Access Compliance Report

Public Rights-of-Way

(Curb Ramps)

Intersection ID: N/A	Main Street: MULLAN_LN	Cross Street: REALTA_DR	Location: SW
ADA ID: 1ADF8F50B478	Ramp Type: Perp	Initial Pass/Fail: Fail	Overall Compliance: No
			Severity Score: 21.25

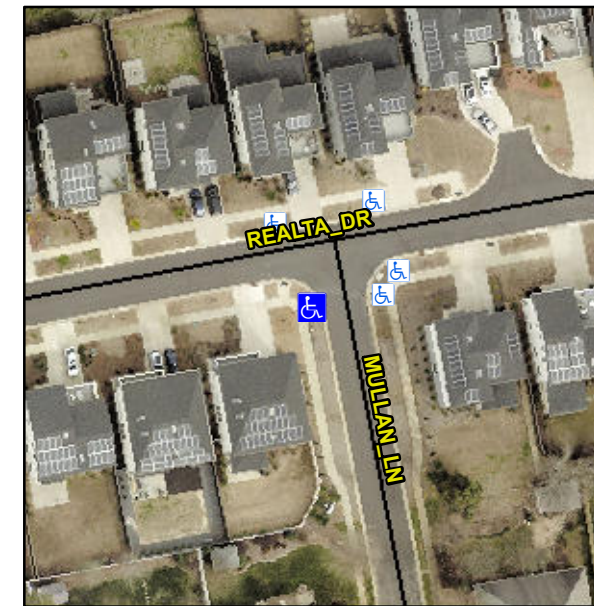
Not Found, R304.5.1, R304.5.3

Compliance	Description	Data	Compliance	Description	Data
N/A	Ramp Length (in)	95.5	Yes	Ramp Slope (%)	5.6
No	Ramp Width (in)	45.0	No	Ramp XSlope (%)	5.7
N/A	Flare Type LT	N/A	N/A	Flare Type RT	N/A
N/A	Flare Slope LT (%)	N/A	N/A	Flare Slope RT (%)	N/A
N/A	Flare Traversable LT?	N/A	N/A	Flare Traversable RT?	N/A
N/A	Landing Length (in)	N/A	N/A	DWS Provided?	N/A
N/A	Landing Width (in)	N/A	N/A	DWS Contrast?	N/A
N/A	Landing Slope (%)	N/A	N/A	DWS Length (in)	N/A
N/A	Landing X Slope (%)	N/A	N/A	DWS Full Width?	N/A
N/A	Landing Curb? (Y/N)	N/A	N/A	DWS Offset (in)	N/A
N/A	Shared Landing?	N/A			
N/A	Gutter Ponding?	N/A	N/A	Gutter Slope (%)	N/A
N/A	Gutter Lip Ht (in)	N/A	N/A	Gutter X Slope (%)	N/A
N/A	Painted X Walk1?	No	N/A	Painted X Walk2?	N/A
	X Walk 1 Direction	To E		X Walk 2 Direction	N/A
N/A	X Walk 1 Width (in)	N/A	N/A	X Walk 2 Width (in)	N/A
	X Walk 1 Slope (%)	4.4		X Walk 2 Slope (%)	N/A
	X Walk 1 X Slope (%)	2.6		X Walk 2 X Slope (%)	N/A

Remove & Replace Entire Ramp.
